Re: Nottingham Hills Subdivision

Lot Line Revisions to Lot 19 & 21 1 Lot Re-Subdivision Lots 19& 21

Date: November 9, 2020 To: Gesick & Associates, P.C.

Subject Property: Upper Kensington Dr - Lots 19 & 21, East Lyme

Sheet Index
Sheet 1 - Title Sheet
Sheet 2 - Existing Conditions Survey
Sheet 3 - Subdivision Plan & Site Plan
Sheet 4 - Septic & Well Plan
Sheet 5 - Details

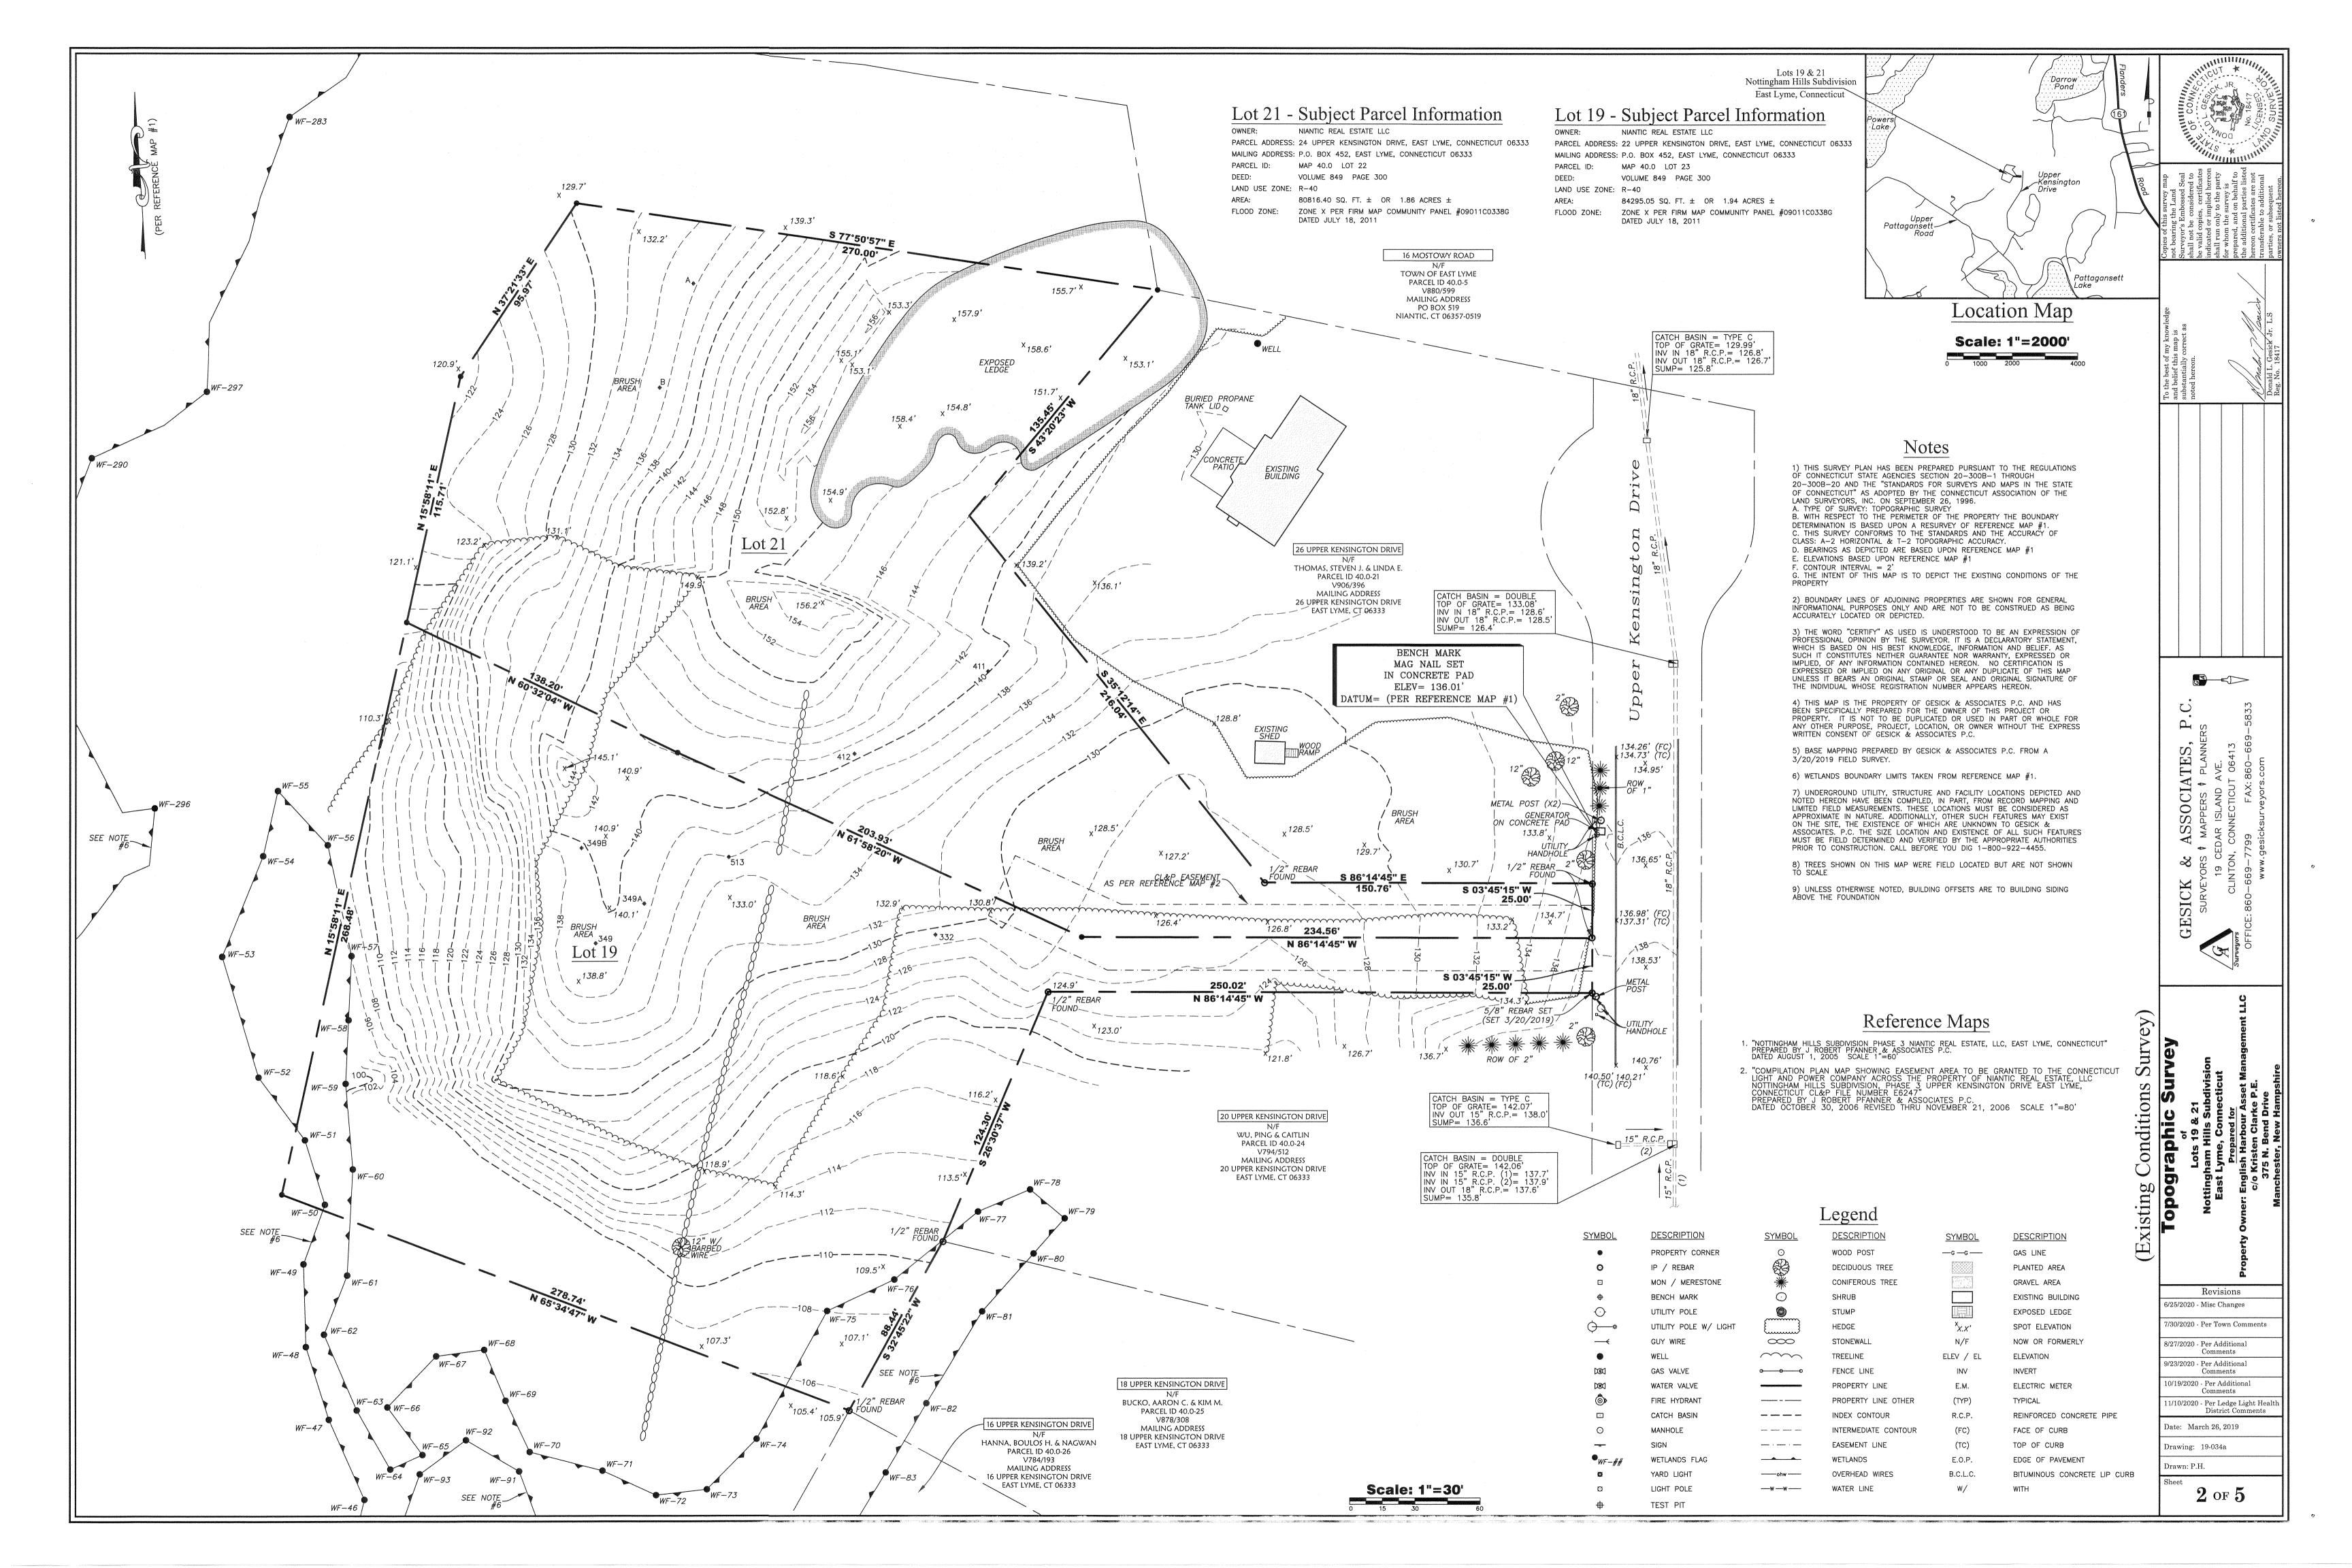
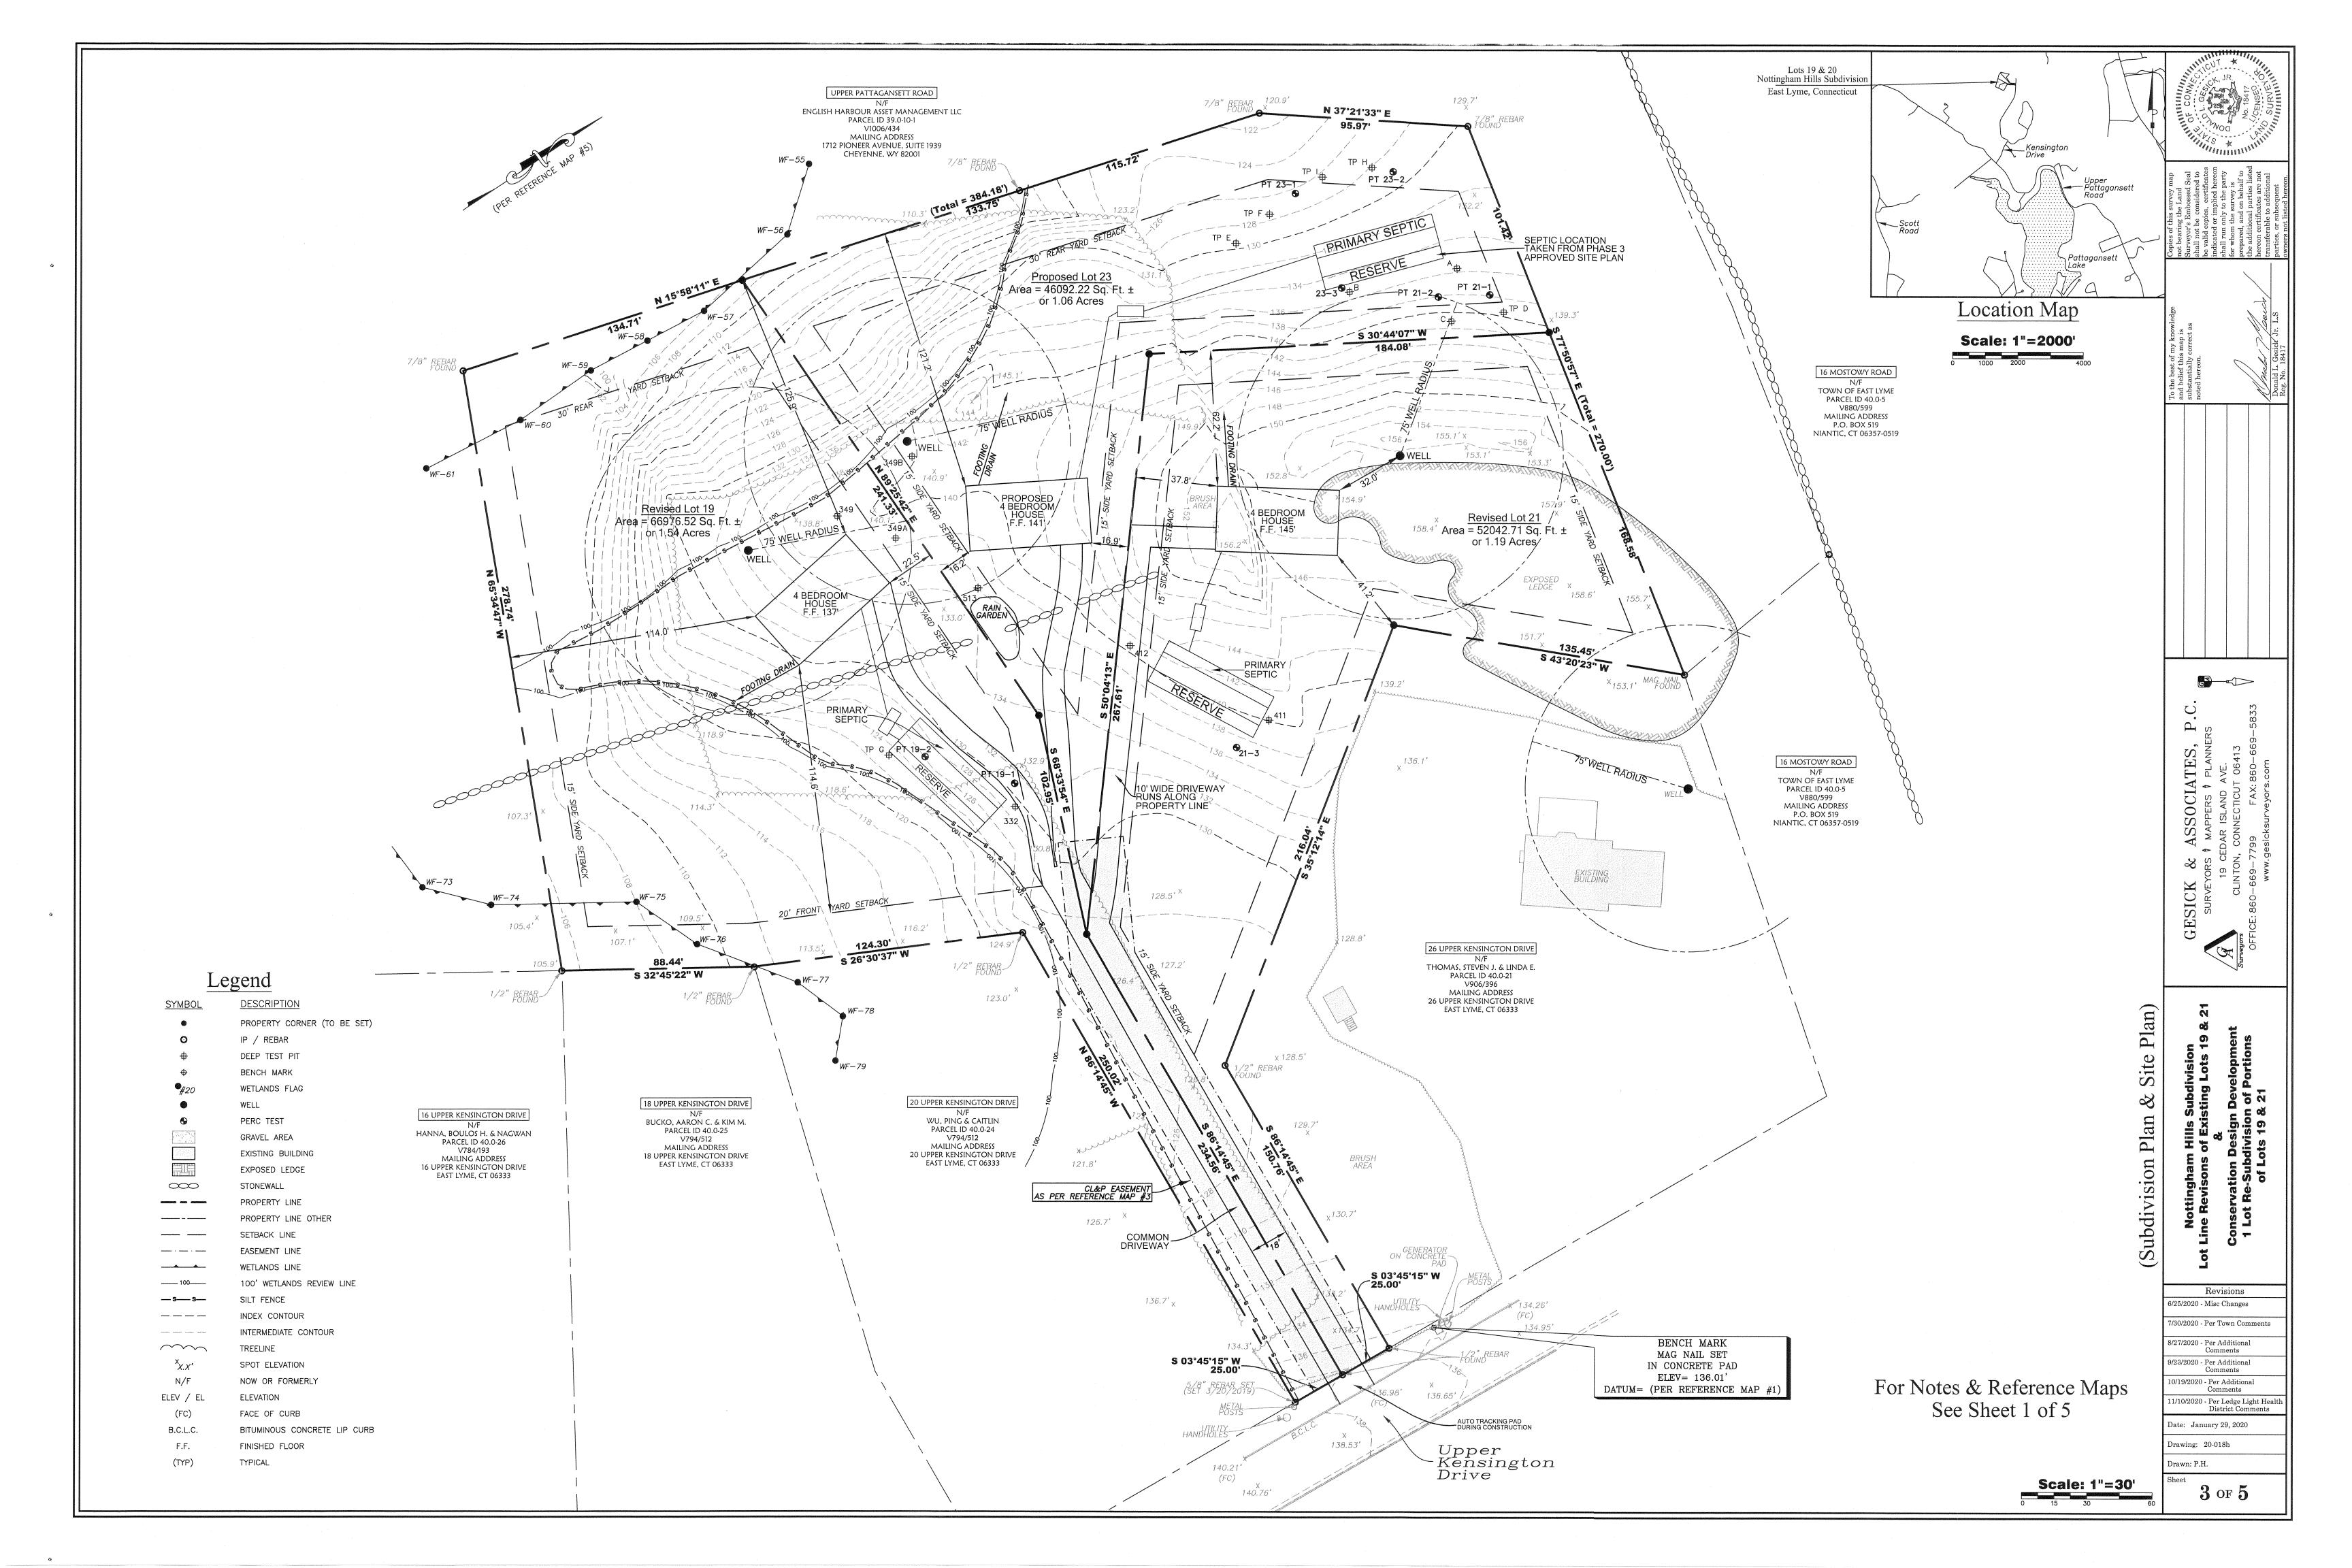
Revised Lot 19 is recommended <u>conditionally</u> suitable, subject to the proposed well location being altered on individual lot site plans to satisfy the required 25' setback from the foundation drains shown around the perimeter of the new home. It is recommended that the well also be relocated resulting in the entire well arc being kept on the property it serves. It appears the revised lot lines affecting this lot configuration would allow both of those revisions to be achieved at the time of building permit application.

Proposed Lot 23 & Revised Lot 21 are <u>not</u> recommended suitable in their current condition and the following issues are to be addressed:

- Both the Primary and Reserve septic areas for Lot 23 are proposed where unsuitable soil conditions were encountered. Unsuitable soil conditions include areas with less than 18 inches of soil above maximum groundwater or less than 4 feet of soil above ledge rock.

- 2. Lot 21 as proposed shows the Primary leaching system area where unsuitable soil conditions were encountered around the perimeter of the system. In the case of existing single-family residential building lots created prior to January 1, 2007, an area with <u>potentially</u> suitable soil must be identified. Potentially suitable soil contains less than 4 feet of existing soil above ledge rock but at least 2 feet of which is naturally occurring soil. The applicant could use the plan (at the risk of the property owner, no guarantees are provided of suitability by LLHD) to make the untuiable area serving existing Lot 21 suitable according to health code (minimum 4' to ledge). To use said plan as a guidance plan, the following must be conducted:

- e. Once this process is complete and all steps approved by LLHD, the proposed septic areas may be approved as suitable by LLHD.
- 3. MLSS calculations are not noted. Based on non-typical ledge encountered in most test pits, MLSS applies to all proposed lots.

- 4. Proposed underground electrical line or other underground utilities are not shown.
- 5. A proposed water treatment wastewater discharge system is recommended to be shown on the plans for potential treatment of well water.

- 6. A description of the proposed septic tanks (size and type) are not included.
- 7. A description of the proposed leaching system for each lot is not provided and thus it cannot be determined whether Effective Leaching Area is satisfied for each proposed home.

- On page 3 and 4 of 5 we relocated the system area, and septic tank, to a location in front of the house Test Holes ("T.H.") 411 & 412, and 4 min perc test location which were all identified in the Nottingham Hills Subdivision Phase 3 plans and have been included at all times on the current applications plans. As noted on page 4 of 5 of the current plans T.H.'s 411 & 412 both were dug to a depth's of over thirteen feet (13') T.H. 411 was dug to 157". T.H. 412 was dug to 168".
- We relocated the proposed driveway closer to the southwestern property line.
- We relocated the proposed well location and well arc.
- We relocated the rear property line of this lot to add additional area to proposed lot 23.
- We added notes to page 4 of 5 to reflect each lot would have a 1500 gallon septic tank and use a Geomatrix product GST 6236 leaching system.

We relocated the boundary of this lot to allow the use of the code compliant septic area approved for lot 21 in the Nottingham Hills Subdivision Phase 3 plans for the proposed lot 23 in the current application. This system area, both Primary & Reserve, was plotted exactly as was previously approved using test holes A & B and the perc test identified in both the aforementioned "phase 3 Plans" as well as the current applications plans page 4 of 5.
